**ADDENDUM NUMBER ONE**

**RFQ # 7548517**

**TITLE: Pier HH Replacement Project, Port of Galilee, DEM**

**A PIER H-H PLAN**  
SCALE: 1/8" = 1'-0"

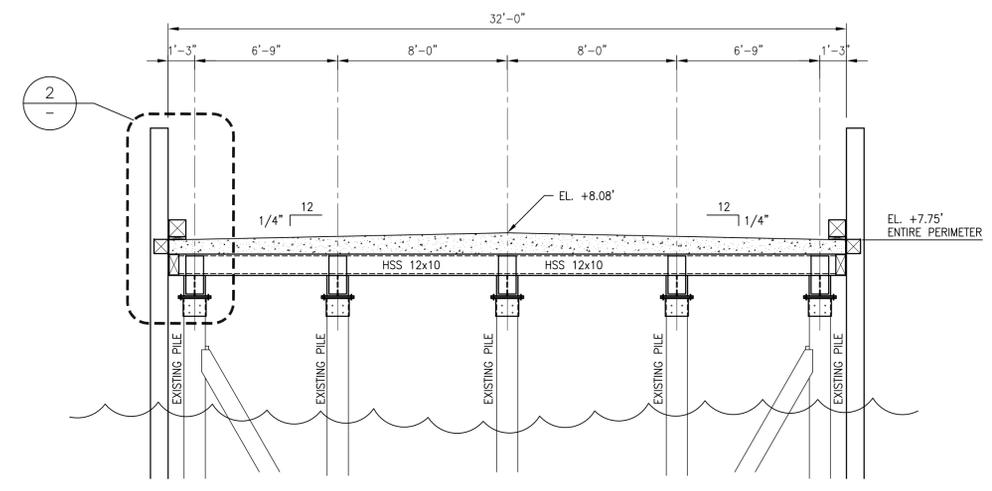
1. Pile Load Testing: 10 blows specified and no pile capacity for selecting the hammer; Is there a minimum pile capacity we are trying to reach?

Response: The piles shall be dynamically tested up to a capacity of 30 tons. An additional test pile has been added to the project. Refer to Drawing C102 rev 1.

**TEST PILE NOTES:**  
 1. TEST PILE TO BE DYNAMICALLY TESTED TO A CAPACITY UP TO 30 TONS. REFER TO TIMBER PILE SPECIFICATION.  
 2. SUBMIT TEST PILE RESULTS TO THE ENGINEER FOR APPROVAL PRIOR TO CONTINUING WITH THE DECK REPLACEMENT.

**1 SECTION**  
SCALE: 1/4" = 1'-0"

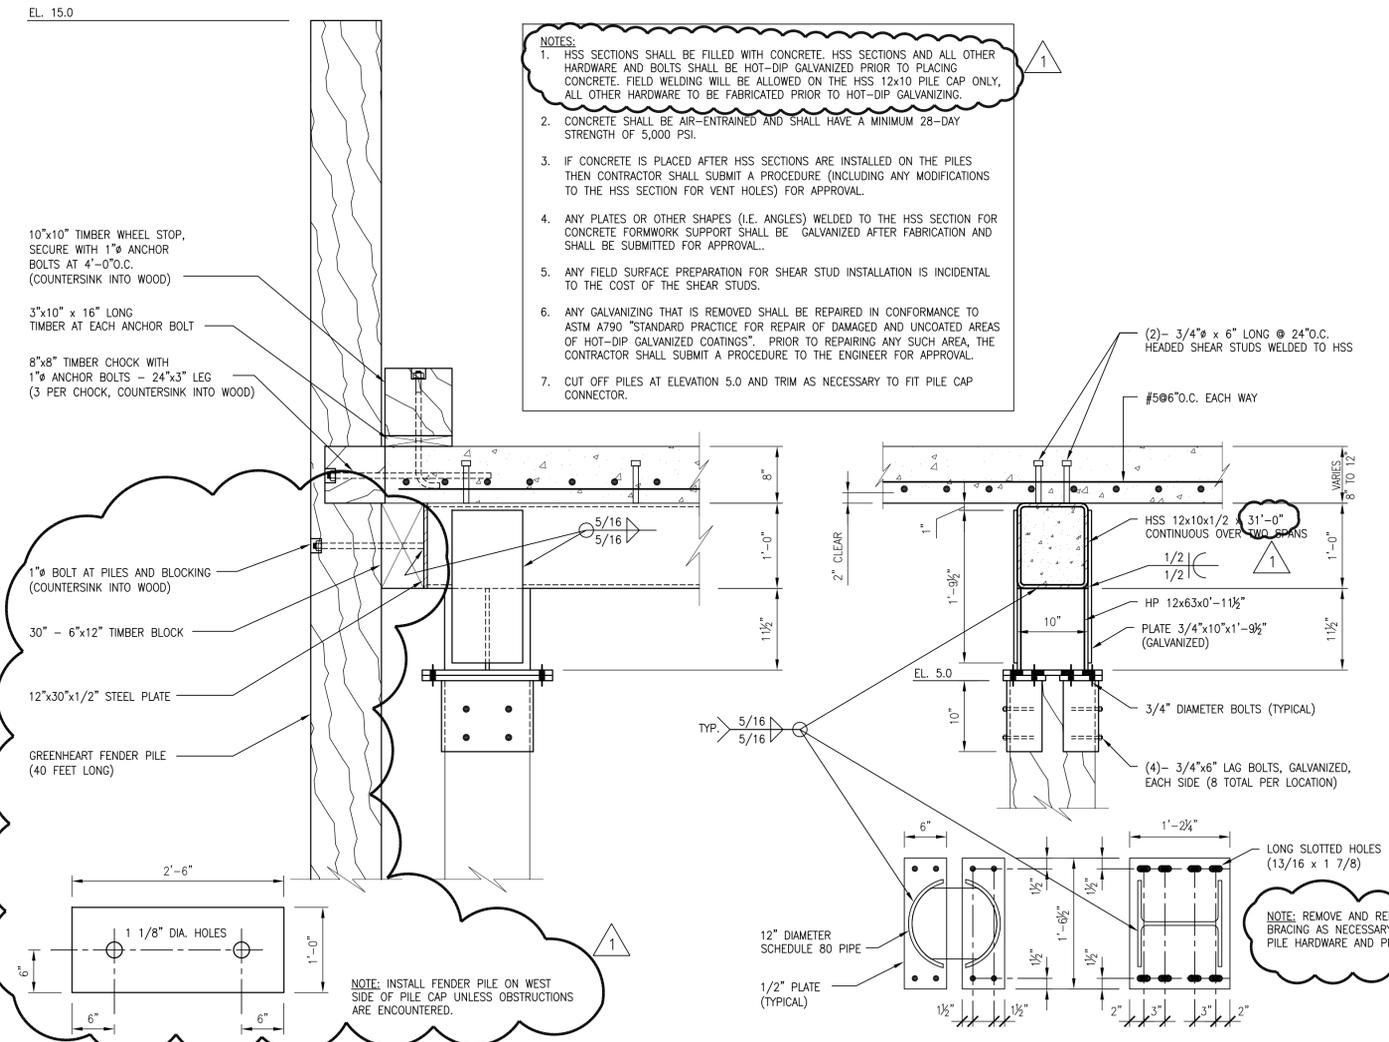
2. Steel Tubing: Fill prior to placement or after? And if pre-filled, weld plates in the field or pre-fabricate?

3. Post-up detail on top of X bracing; are we to remove and re-install existing X braces?

Response: The concrete fill may be placed before or after they are installed, if filled after installation, refer to Note #3 on C102. The plates connecting the pile extension may be field welded, all other welding to be performed prior to hot –dip galvanizing, refer to revised Note #1 on C102 rev 1.

Response: Existing timber bracing is to remain in place, remove and reinstall bracing where necessary to install pile hardware and cap, refer to revised Note on Section 3 C102 rev 1.

**NOTES:**  
 1. HSS SECTIONS SHALL BE FILLED WITH CONCRETE. HSS SECTIONS AND ALL OTHER HARDWARE AND BOLTS SHALL BE HOT-DIP GALVANIZED PRIOR TO PLACING CONCRETE. FIELD WELDING WILL BE ALLOWED ON THE HSS 12x10 PILE CAP ONLY. ALL OTHER HARDWARE TO BE FABRICATED PRIOR TO HOT-DIP GALVANIZING.

2. CONCRETE SHALL BE AIR-ENTRAINED AND SHALL HAVE A MINIMUM 28-DAY STRENGTH OF 5,000 PSI.  
 3. IF CONCRETE IS PLACED AFTER HSS SECTIONS ARE INSTALLED ON THE PILES THEN CONTRACTOR SHALL SUBMIT A PROCEDURE (INCLUDING ANY MODIFICATIONS TO THE HSS SECTION FOR VENT HOLES) FOR APPROVAL.

**2 SECTION**  
SCALE: 1" = 1'-0"

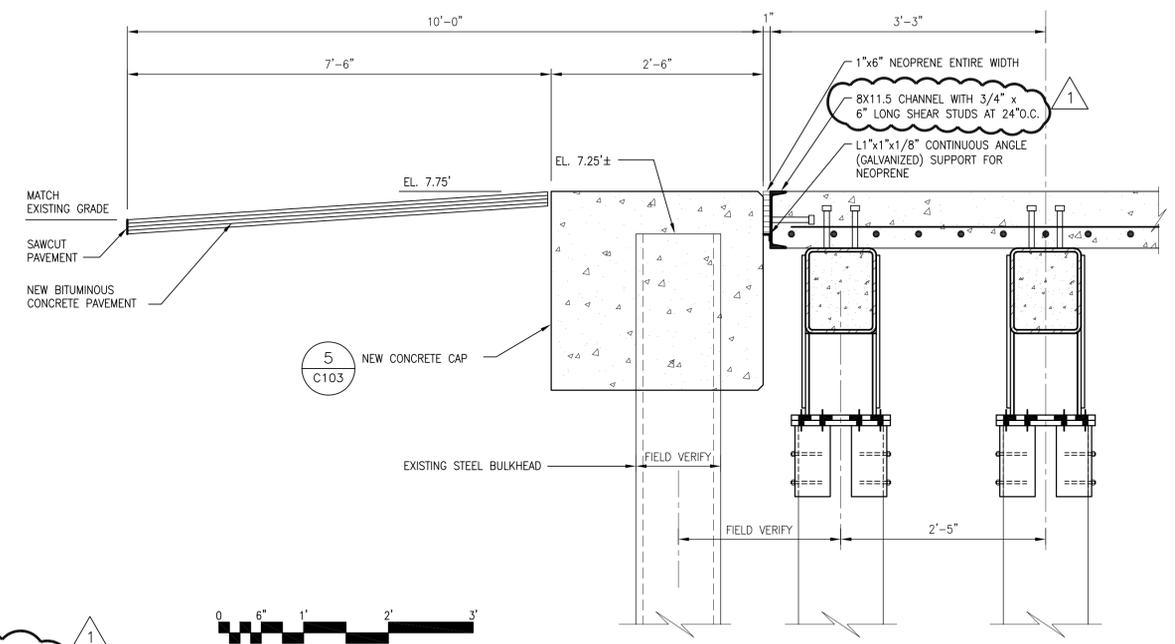
4. All connection details show threaded bars embedded in concrete; will expansion bolts be acceptable? Tough to drive piles with rods sticking out.

5. Pier gets very heavy use; If fenders break it will be difficult to replace them. Can we revisit the fender attachment detail for ease of replacement?

Response: Expansion bolts are not acceptable, the fender pile installation detail has been revised to use through bolts, refer to Drawing C102 rev 1 and C104 rev1.

Response: The fender pile installation detail has been revised to use through bolts with two potential fender pile locations, refer to Drawing C102 rev 1 and C104 rev1.
